Australian Air Publication 721.79

**Volume 2, Part 2
Book 3**

VAMPIRE MODIFICATIONS

(Nos 201 to 300)

DE HAVILLAND DWG NO 00M 347 SHEET 1 OF 3 SHEETS

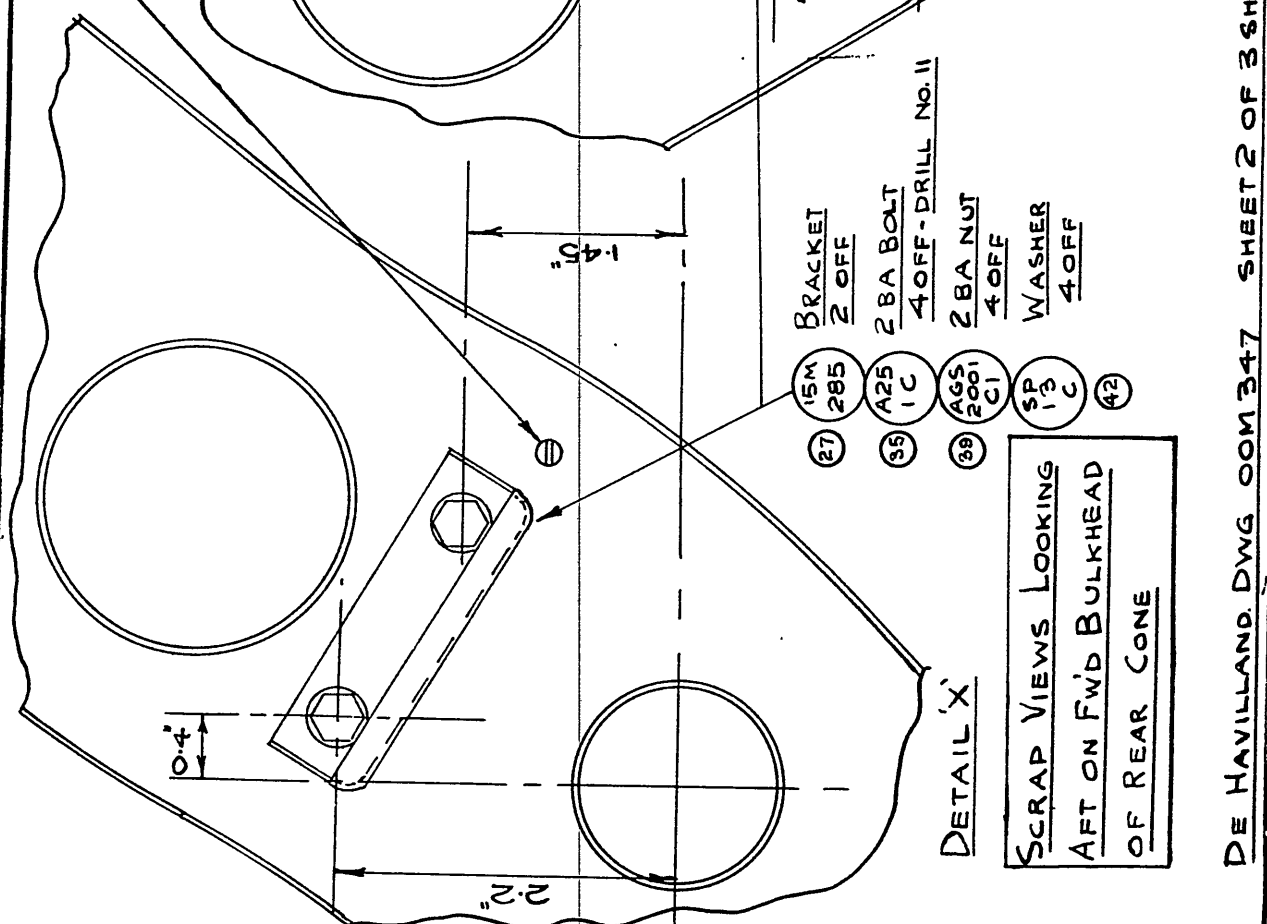
- * (lx) Reposition breeze plug as shown on leaflet drawing No ~~60347~~ Sheet No 1.
A12969
- * (lxi) Drill 8-No 11 (.191") dia holes on front bulkhead of cone as shown on leaflet drawing No ~~60347~~ Sheet 1 & 2 and assemble bracket (Item 27) 2-off with bolts, nuts and washers (Items 35, 39 and 42) 4-off each.
A12969

DE HAVILLAND DWG 00M347 SHEET 2 OF 3 SHEETS

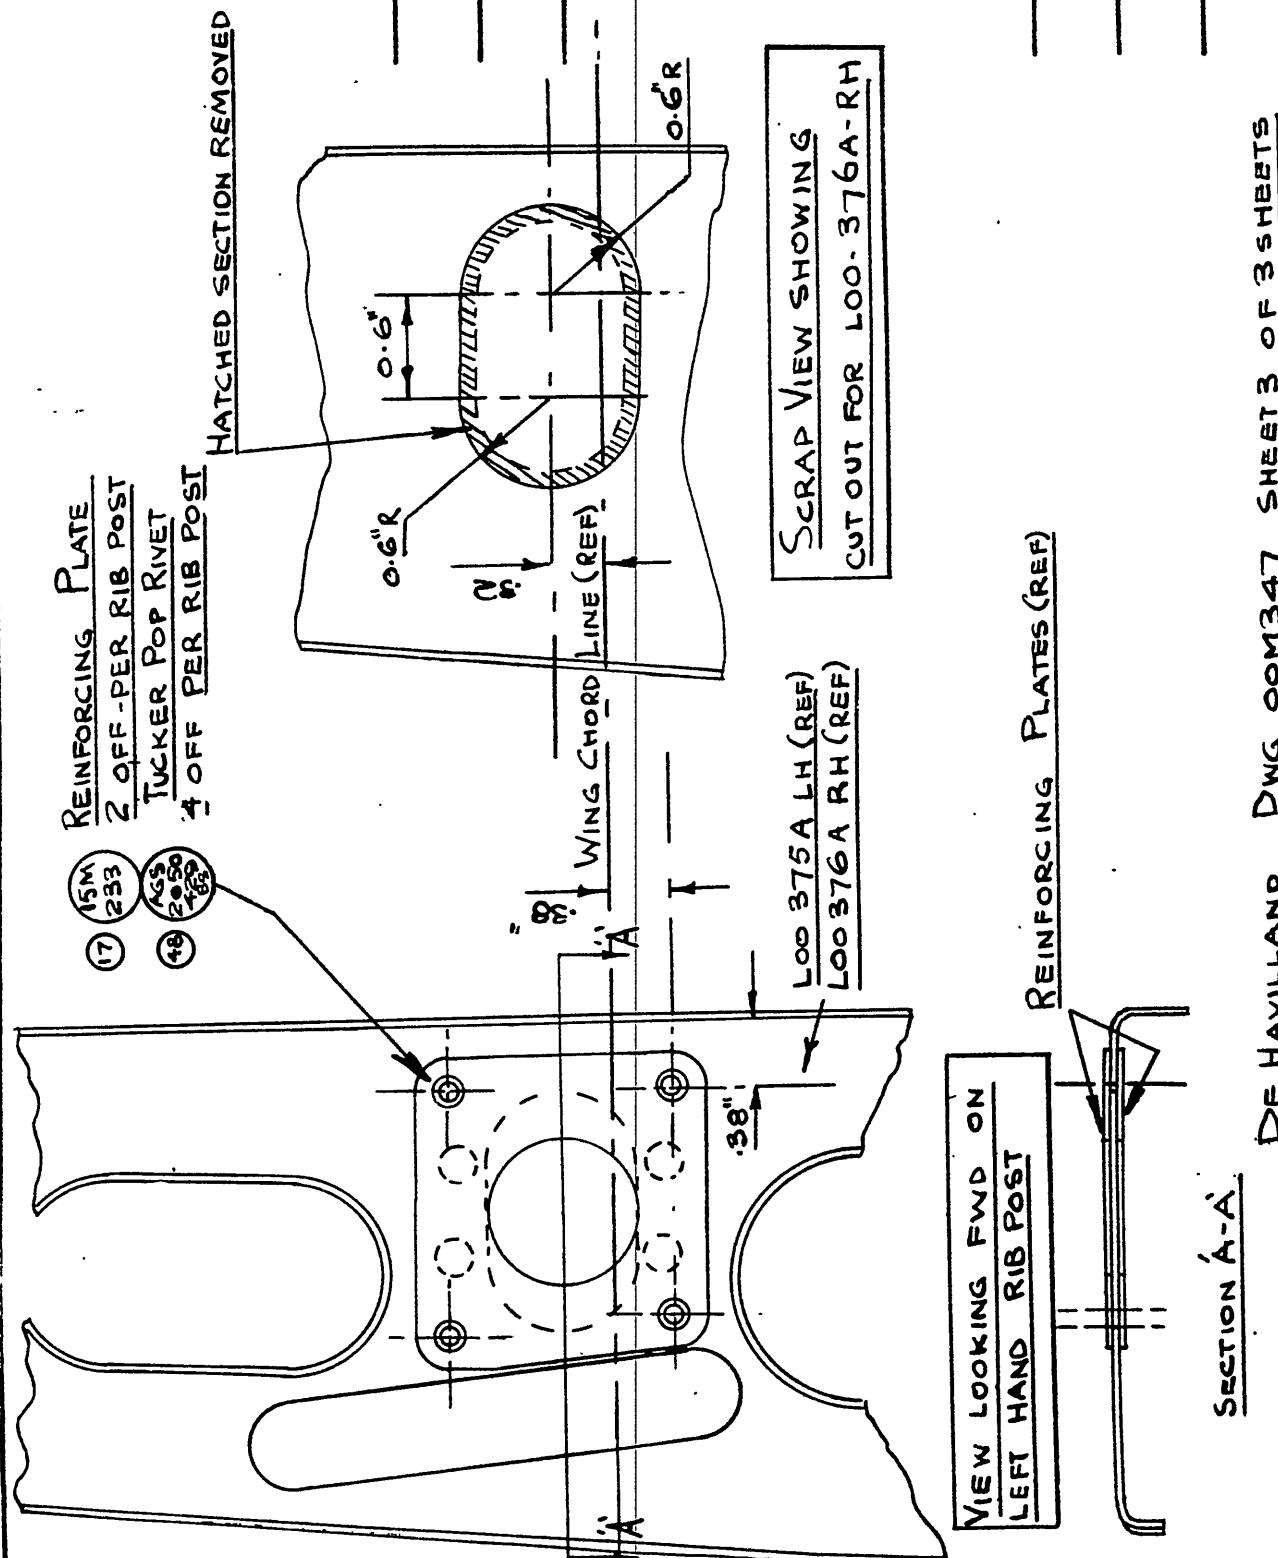
REPOSITION BOLT FOR P-CLIP
TO CLEAR BRACKET AS & WHEN
NECESSARY

SHEET 3 OF 11 SHEETS.

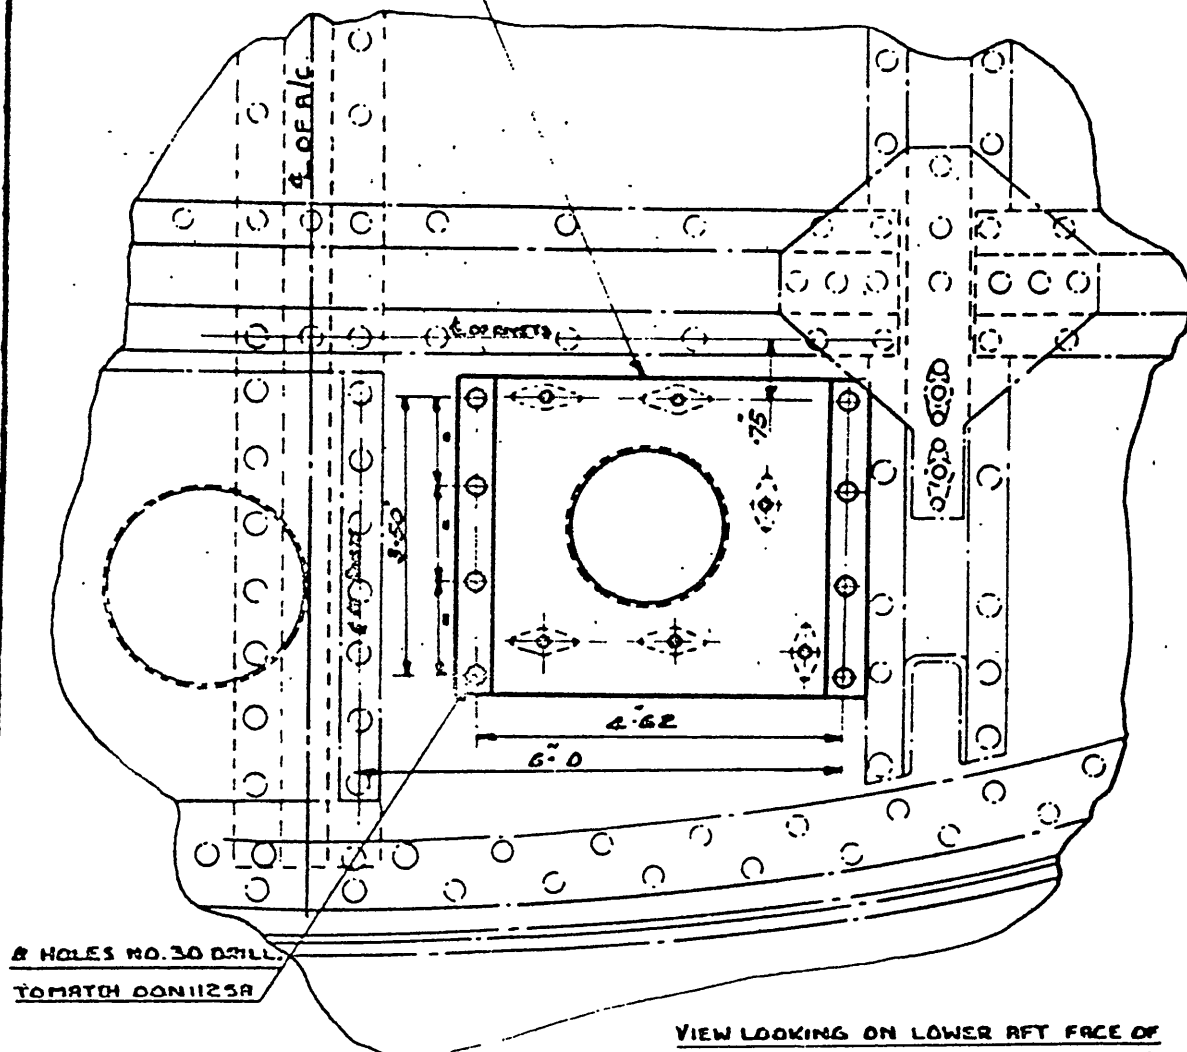
- (xi) Refer to Drawing A12980 sheets 3 and 5. At the aft face of bulkhead No 4 proceed to modify by adding new mounting bracket (item 4) 1 off using rivets (item 8) 8 off; Relay type 'S4' (item 5) 1 off using screws (item 6) 4 off and also re-fit the 5 way terminal block (retained in para vii) to the mounting bracket (item 4) using existing screws (also retained in para (vii)).
- (xii) Refer to Drawing A12980 sheet 4. Obtain two of the three cable looms disconnected and removed in para (viii), one previously running to the plug on Rib 1 (Port) the other previously running to the plug on Rib 1 (Stbd) and proceed to modify them as shown using cable (Item 12) and (Item 11), 5 M/M i/d black nyllex tubing (Item 15) and cord (Item 16) treated with Beeswax (Item 17). After modifying the two cable looms re-part number them viz.

DE HAVILLAND DRAWING NO. 00N 341 SHEET 5 OF 11 SHEETS.

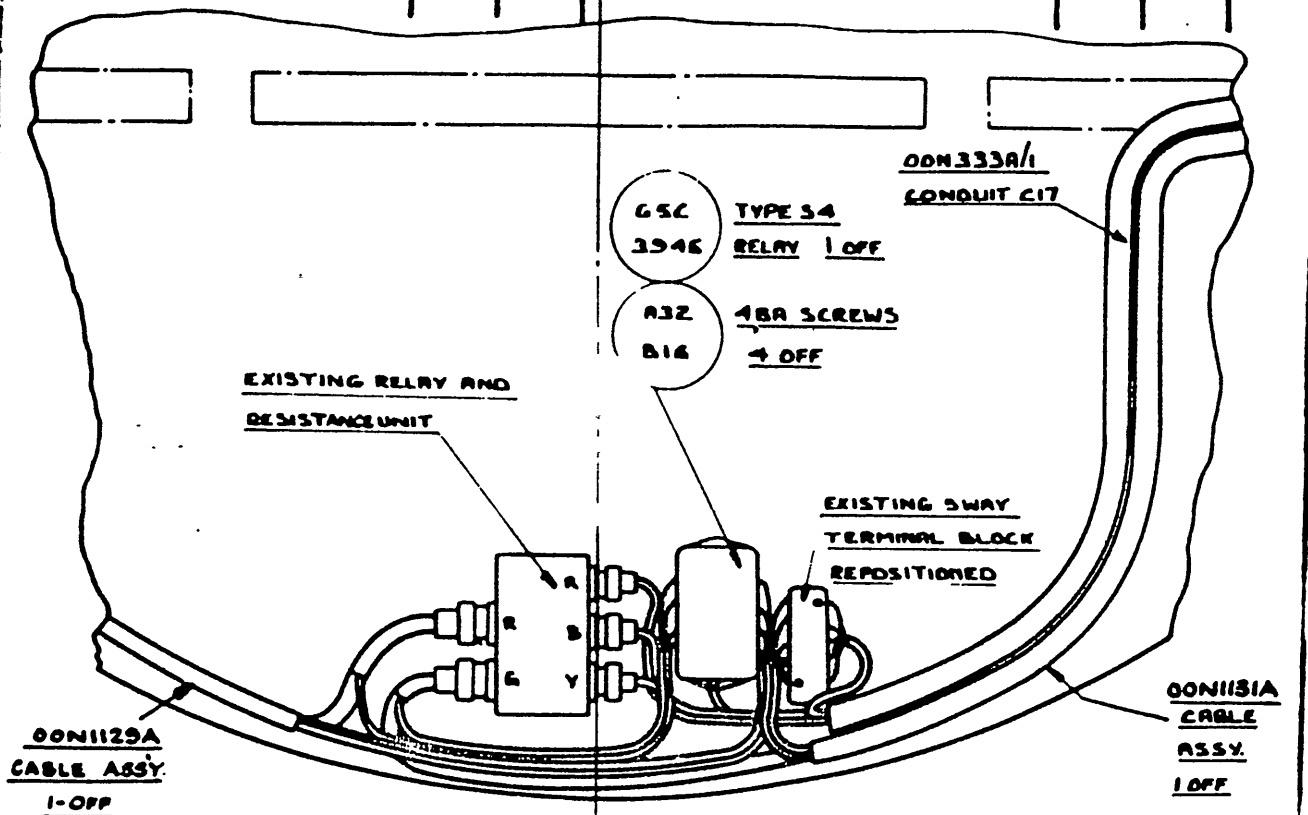
- (xix) Refer to Drawing A12980 sheet 5. Install the three modified cable looms part No 's OON1129A, OON1131A and OON333A/1 by routing them in a similar manner to the previous installation, using cord (Item 16) treated with Beeswax (Item 17) for whipping to existing cables and/or structure. For details of wiring connections at equipment on aft face of bulkhead No 4 refer closely to the attached drawing.

DE HAVILLAND DRAWING NO. DOM 341 SHEET 6 OF 11 SHEETS.

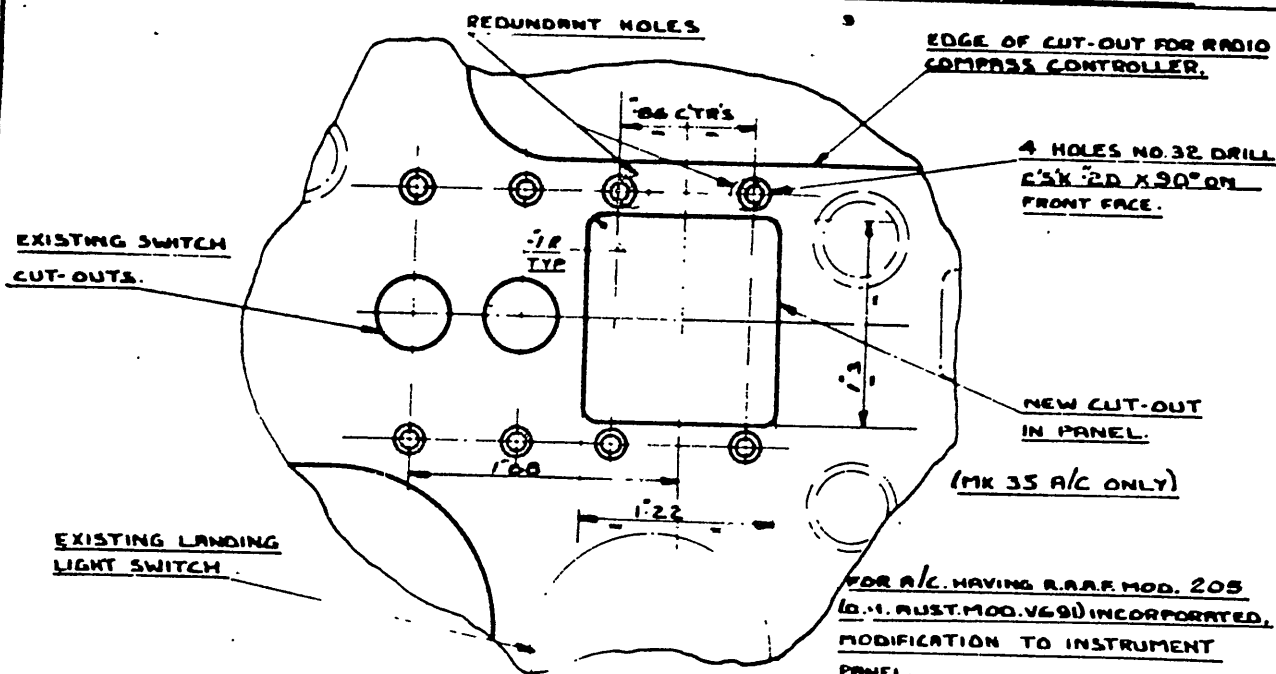
- (vi) Refer to Drawing A12930 sheet 6 and proceed to modify the instrument panel according to details given.

- (viii) Refer to Drawing A12980 sheet 6 and connect cable coded 'RP2' (disconnected in sub-para (v)) to the new switch. Remove existing cable coded 'RP3' (disconnected in sub-para (v)), re-code 'CG7' and then install as shown on drawing.

- (iv) On the instrument panel supplied with modification set for RAAF Vampire Mod 205 (DH Aust Mod V 691) assemble the switch (Item 41) using existing screws and stiffnuts (Item 46) 4 off as shown on Drawing A12980 sheet 6.

- (x) Install the reworked loom in accordance with instructions laid down in RAAF Vampire Mod 205 (DH Aust Mod V691) and make connections to new switch (refer para (iv) above) as shown on Drawing A12980 sheet 6.

DE HAVILLAND DRAWING NO 00M 341 SHEET 8 OF 11 SHEETS.

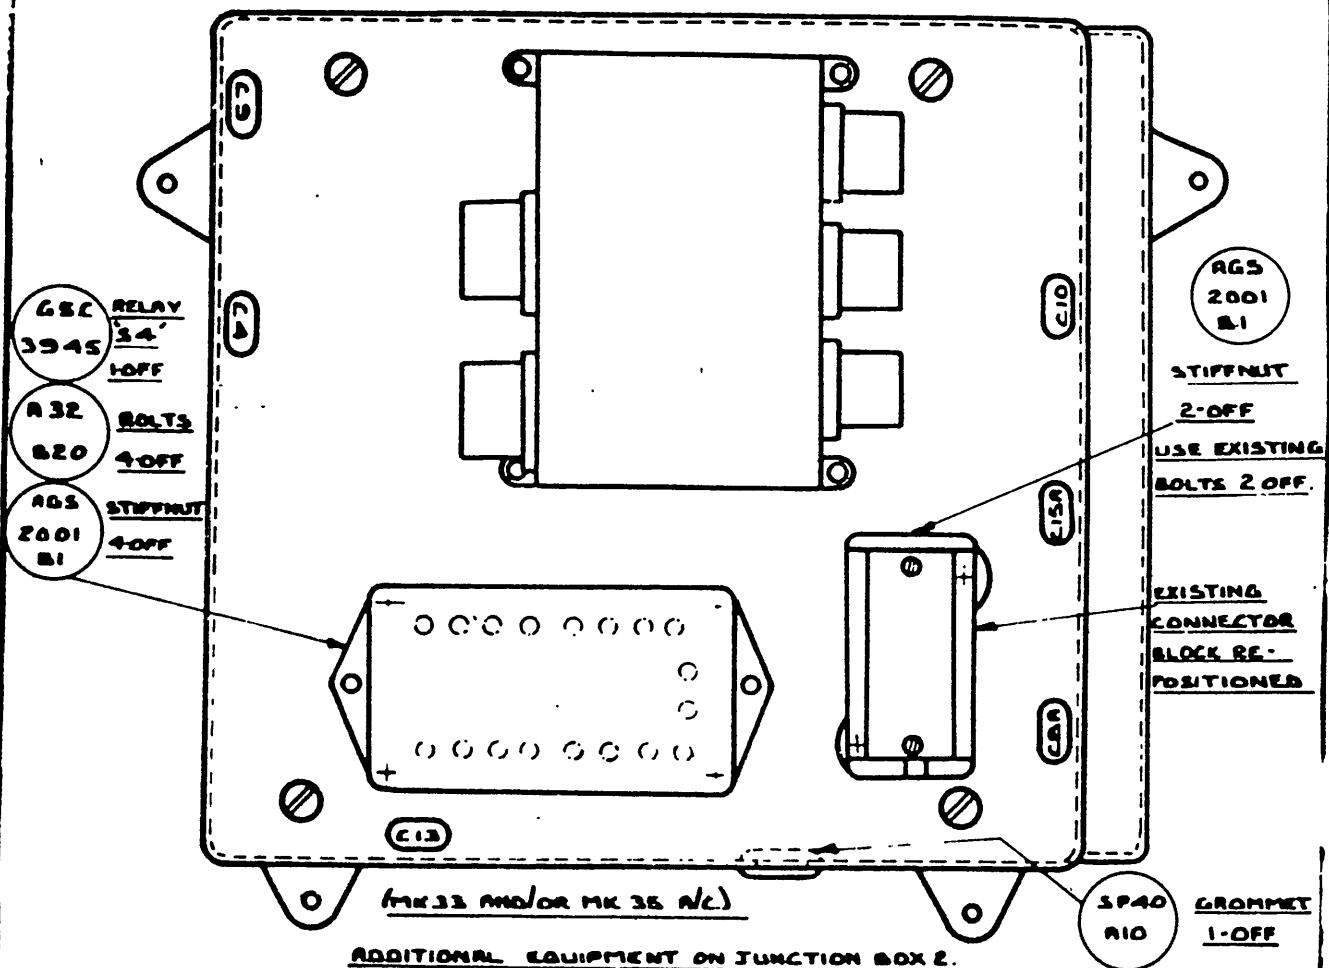
- (xi) Refer to Drawing No A12980 sheets 8 & 9. Obtain Junction Box 2 previously removed in para (iii) and modify as shown using relay (Item 42) and Grommet (Item 48) 1 off each; screws (Item 45) 4 off, stiffnut (Item 46), and cable (Item 49), and nylex tubing (Item 53) part of each. After reworking, the part no of the complete junction box is to be altered to N15-155A/2.

DE HAVILLAND DRAWING NO. DOM 341 SHEET 10 OF 11 SHEETS.

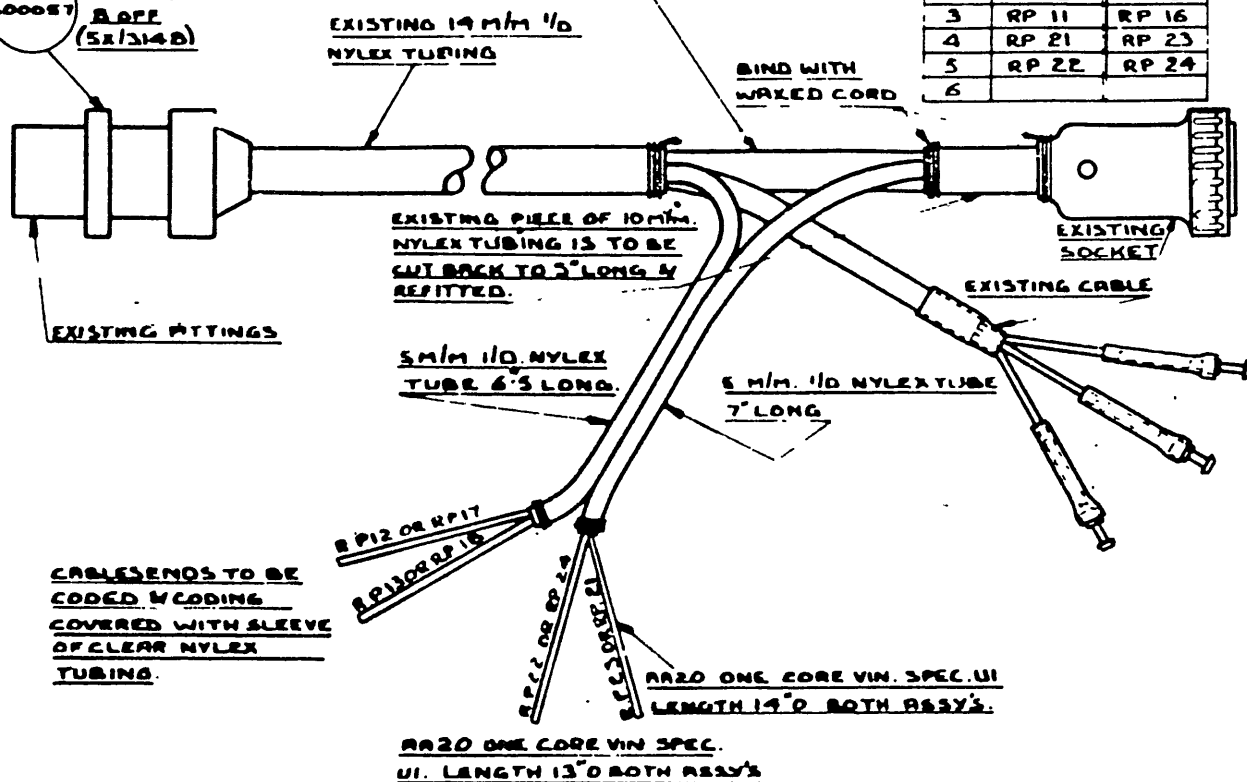
- (xxi) Refer to drawing A12980 sheet 10. Modify the two looms (removed in para (iv) as shown using sleeve (Item 24) thimble (Item 25) 3 off each, cable (Item 31), cable (Item 30) nyllex tubing 5 M/M, i/d (Item 33), nyllex tubing 6 M/M i/d, (Item 34) and cord (Item 38) suitably treated with Beeswax (Item 39). After modifying these looms re-part number them:

- (xii) Refer to Drawing A12980 sheet 10. Modify the two looms (removed in para (iii)) as shown using sleeve (Item 43). Thimble (Item 44) 8 off each; cable (Item 50), cable (Item 49) nylex tubing (Item 52), nylex tubing (Item 53) and cord (Item 55) suitably treated with Beeswax (Item 56). After modifying these looms re-part number them as follows: (Issued with A.L. 122)

DEHAVILLAND DRWG. 00M332. No. of SHEETS 1.

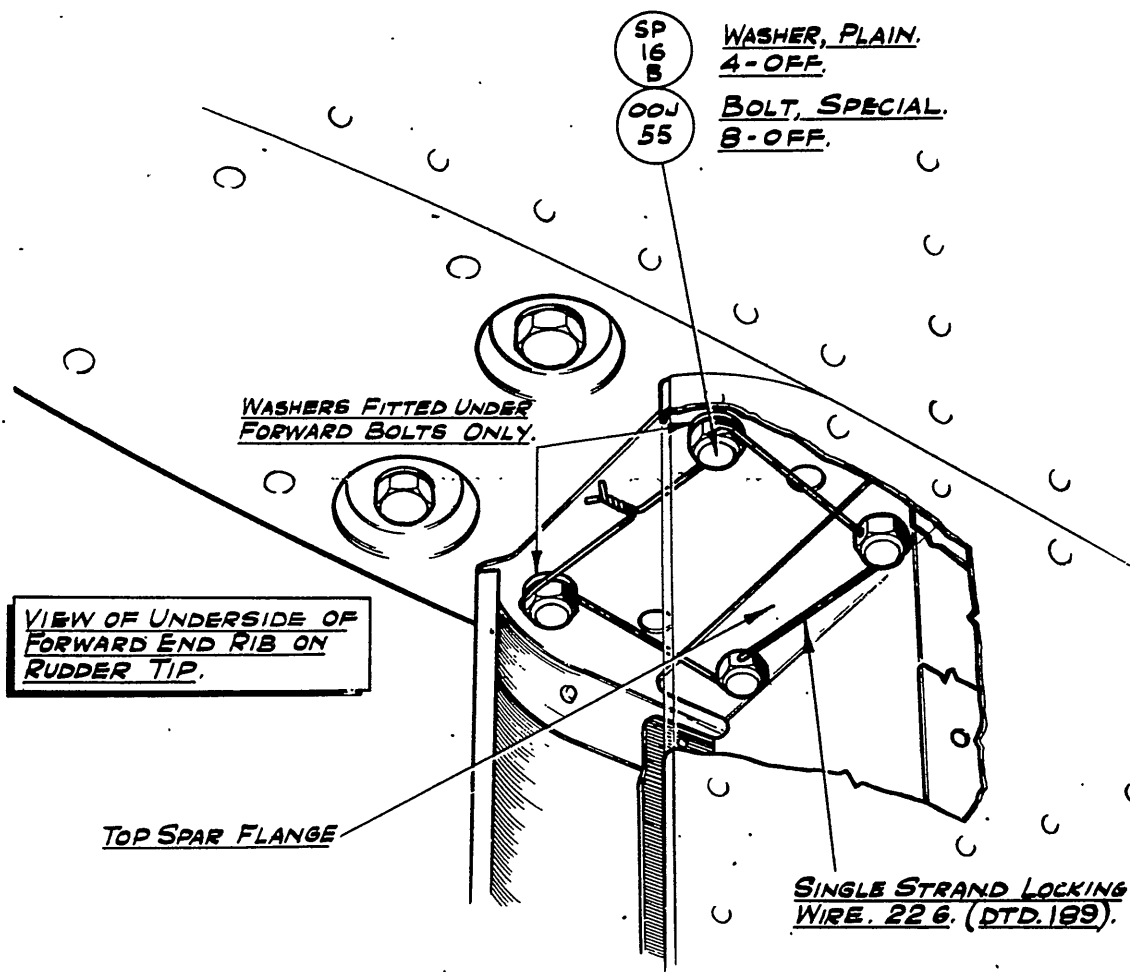
REMOVE AND DISCARD THE EXISTING 2-4BA. BOLTS ATTACHING THE TOP SPAR FLANGE AND THE 2-4BA. BOLTS AND PLAIN WASHERS ATTACHING THE FRONT END OF THE LOWER TIP RIB. FIT THE 4 NEW SPECIAL BOLTS, FIT ONE PLAIN WASHER UNDER FORWARD 2 BOLTS ONLY. LOCK THE 4 BOLTS AS SHOWN ABOVE.. REPEAT ON SECOND RUDDER.
